RE: **Lot 18 Block 5 Unit 22 SAD 228**
Volcano Cliffs
6624 Sujeto Rd. NW
Rev. Grading and Drainage Plan Date: 8/9/2022
Pad Certification Date 12/7/2022 (D10D003K18)

Based upon the information provided in your submittal received 12/14/2022, this plan cannot be approved for Pad Certification until the following comments are addressed.

ENGINEER'S SEAL 8/9/22 4/6/21 DAVID SOULE P.E. #14522	6624 SUJETO	DRAWN BY: WCVJ
	GRADING AND DRAINAGE PLAN	DATE: 4-02-21
 1606 CENTRAL AVENUE SE SUITE 201 ALBUQUERQUE, NM 87106 (505) 872-0999	SHEET # —	JOB # 21021039

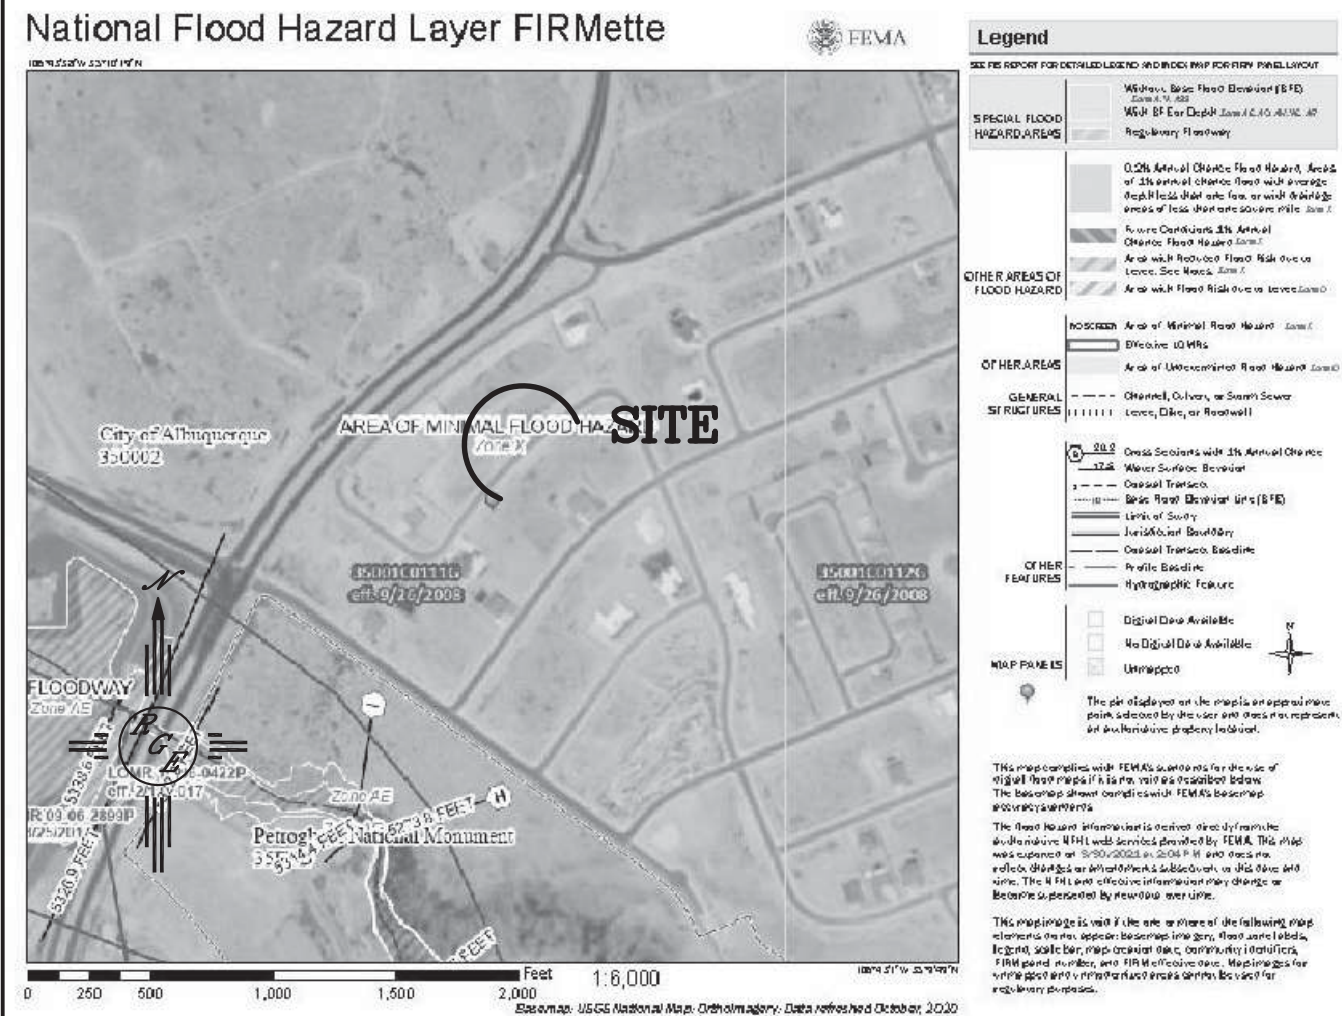
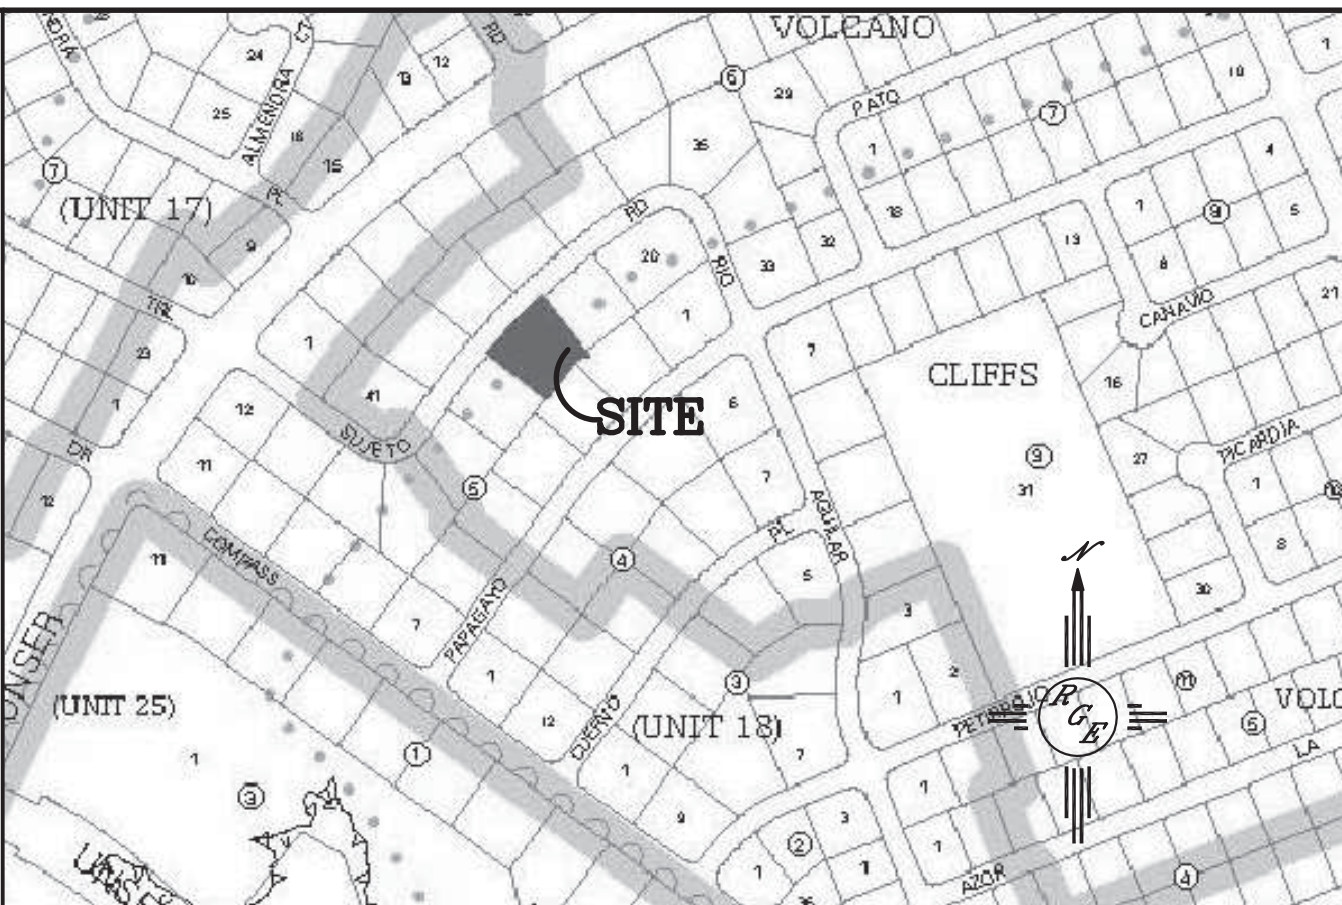
- Provide new land treatment values.
- Provide ponding areas for the home site, new concrete was added and exceeds the land treatment value for SAD 228.
